NUCLEAR REGULATORY COMMISSION

Title: Advisor Committee on Reactor Safeguards
Subcommittee on ESBWR

Date: Friday, September 24, 2010

ESBWR Design Certification
Chapter 7 I&C

Figure 7.3-7
SSLC/ESF Simplified Functional Block Diagram

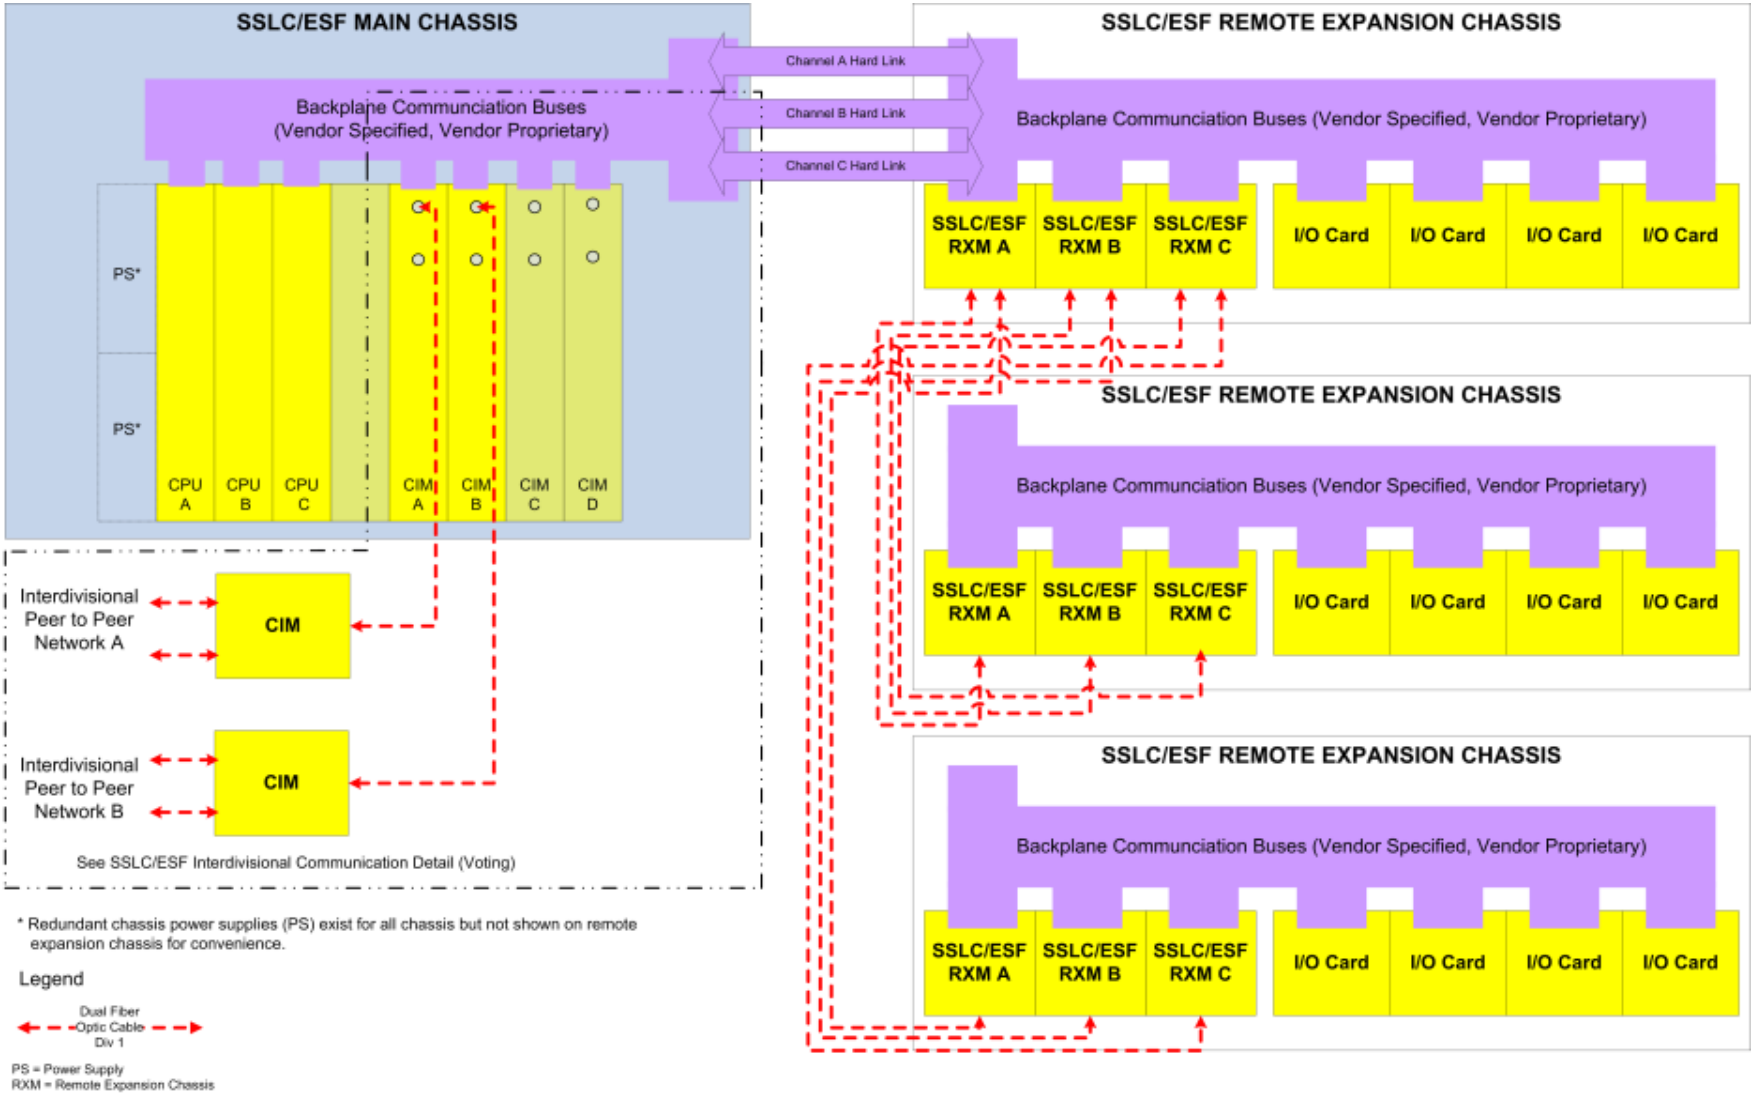
Add'l Design Detail – New Fig. (5/8)… Figure 7.3-7 From: RAI 7.1-139 – Question 3

Figure 7.3-8
SSLC/ESF Inter-Divisional Communication Detail

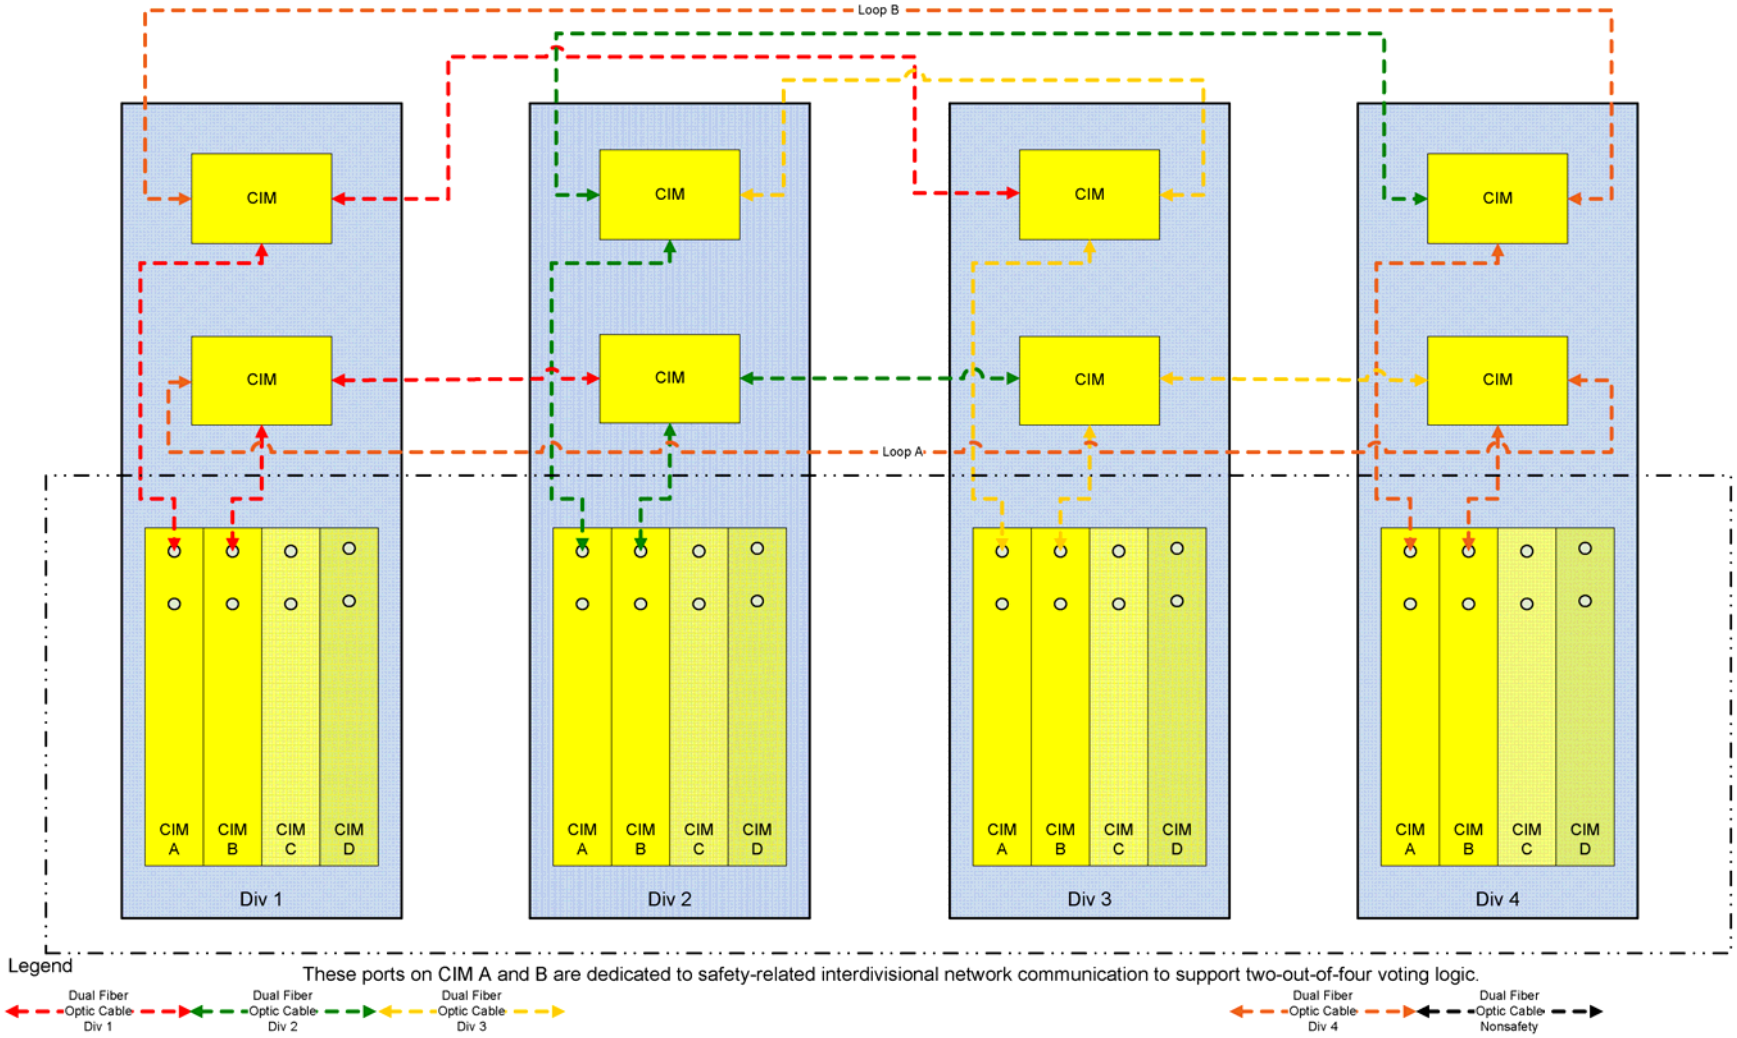
Add'l Design Detail – New Fig. (6/8)… Figure 7.3-8 From: RAI 7.1-139 – Question 3

Figure 7.3-9
SSLC/ESF Safety-Related VDU Communication Detail

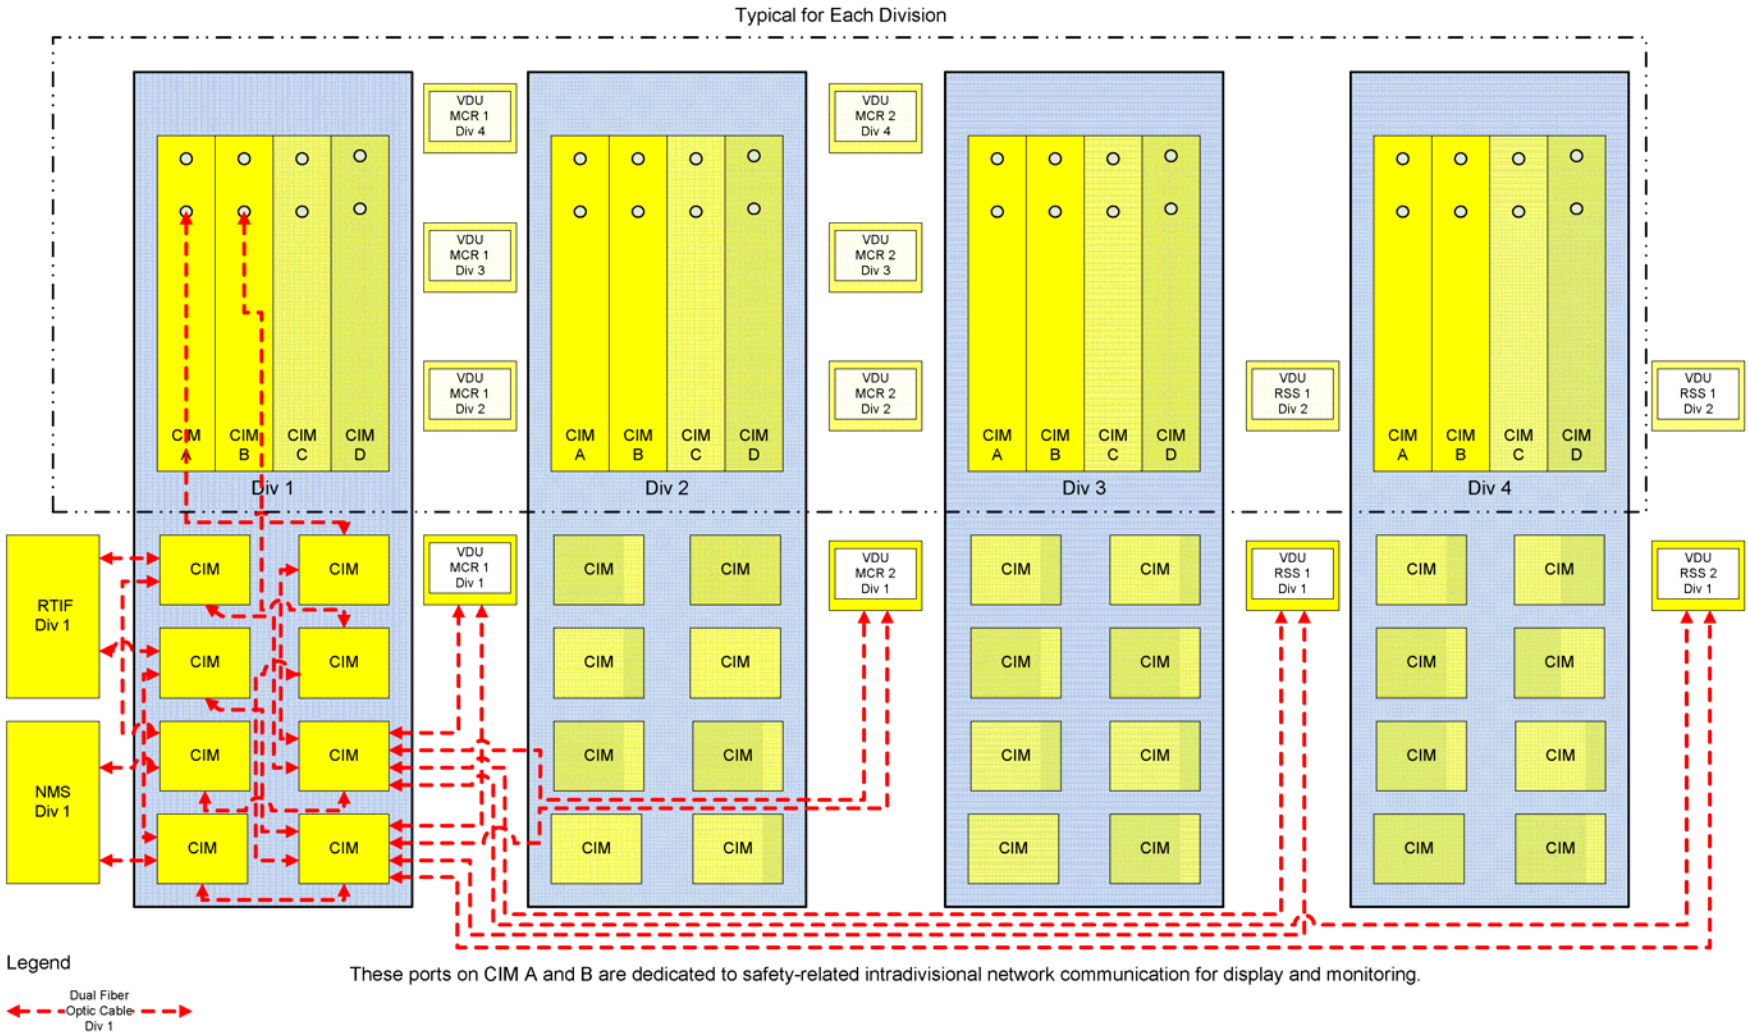
Add'l Design Detail – New Fig. (7/8)… Figure 7.3-9 From: RAI 7.1-139 – Question 3

Figure 7.3-10
SSLC/ESF Nonsafety-Related VDU Communication Detail

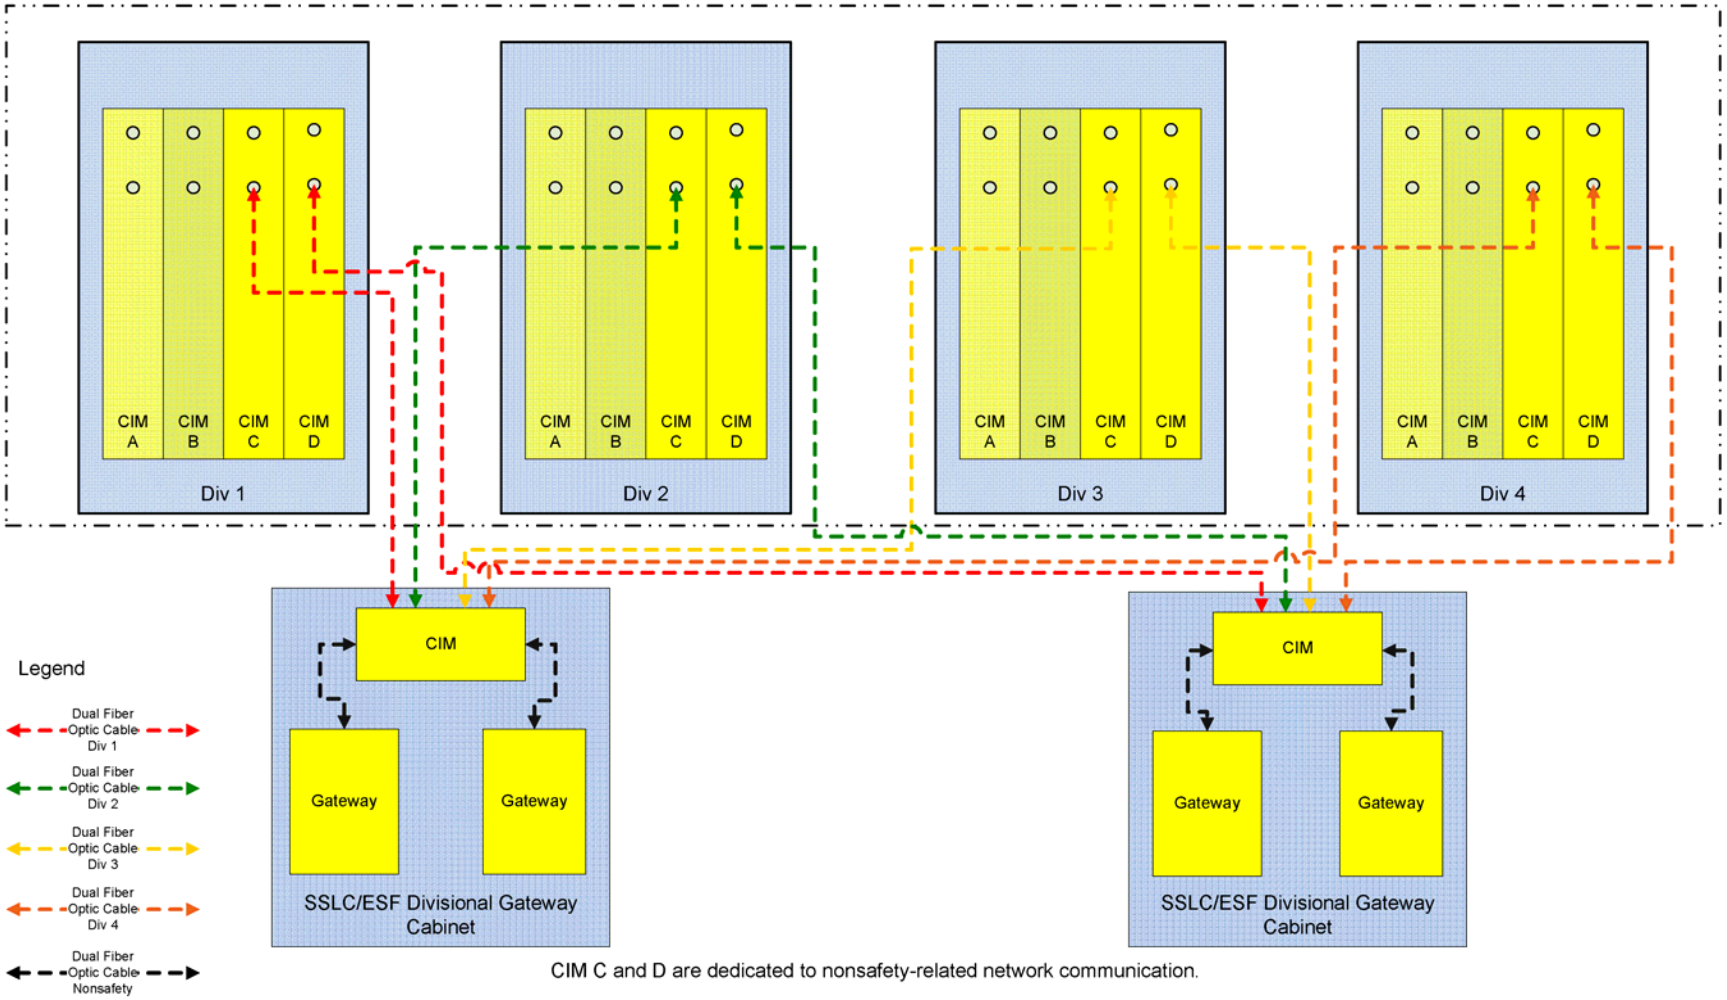
Add'l Design Detail – New Fig. (8/8)… Figure 7.3-10 From: RAI 7.1-139 – Question 3
